Town of Whitestown Board of Zoning Appeals

Meeting Date: May 2nd, 2024

BZA24-001-VA							
Request	To allow for a 10% increase in the Max Density in R3 from 3.00 units per acre to 3.32 units per acre						
Location	608,708,801 S. Main Street						
Applicant	Davis Homes						
Property Owner(s)	Jacob Hogue, Lauren Hogue, Robert & Tracy Blackburn						
Land Area (Size)	17 Acres						
Applicable Ordinance	Whitestown Unified Development Ordinance Section 2.3(B) Lot Requirements						
Property Zoning	R3	R3 Medium Density Single-Family and Two-Family					
Adjacent Zoning	North		East	South	West		
, ,	AG & R3		PUD	R3	R3		
Adjacent Land Use	Agricultural		Residential	Residential	Residential		
Staff Reviewer	Desire Irakoze Dirakoze@whitestown.in.gov						
Staff Recommendation	Staff recommends approval of this request.

PROPOSED SITE PLAN

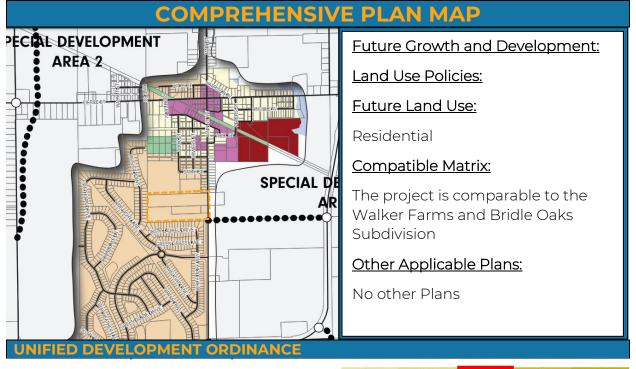
Under Whitestown UDO Section 2.3(B) Lot requirements, the maximum number of dwelling units permissible based on the acre of the site (17) is 50 units. The applicant is proposing a total of 56 dwelling units, comprising 54 new dwelling units, and incorporating 2 existing units. This results in a density of 3.32.

CRITERIA	WITHOUT VARIANCE	WITH VARIANCE
Max Dwelling Units	50	56
Max Density (Units/Acre)	3.00	3.32
Min Lot Size (Sqft)	6,000	6,000
Min Lot Width	50	50
Open Space	10%	21.5%
Trail Connection	No Trial	Trial Provided
Vinyl Siding	Allowed	Not allowed
Main St Streetscape	Not Required	Provided
Retention of Historic Homes	Not Required	Provided
Developer Commitments	Not Required	Provided

- 4. Ensure that the northwest stub street complies with fire truck turning Standards, as outlined in Exhibit A.
- The pedestrian trail and the northwest sidewalk should be no less than 8 feet wide to facilitate future connection to Panther Park. Additionally, ensure that the trail is provided as part of the development.
- 6. Due to the lift station's location, it should be provided with enhanced screening to match the residential
- 7. subdivision's aesthetics.
- 8. Ensure that the subdivision's internal street is aligned with Seabiscuit Road
- □ Continued to the June 6th,2024 , BZA Meeting
- $\hfill\square$ Denied as presented and described.
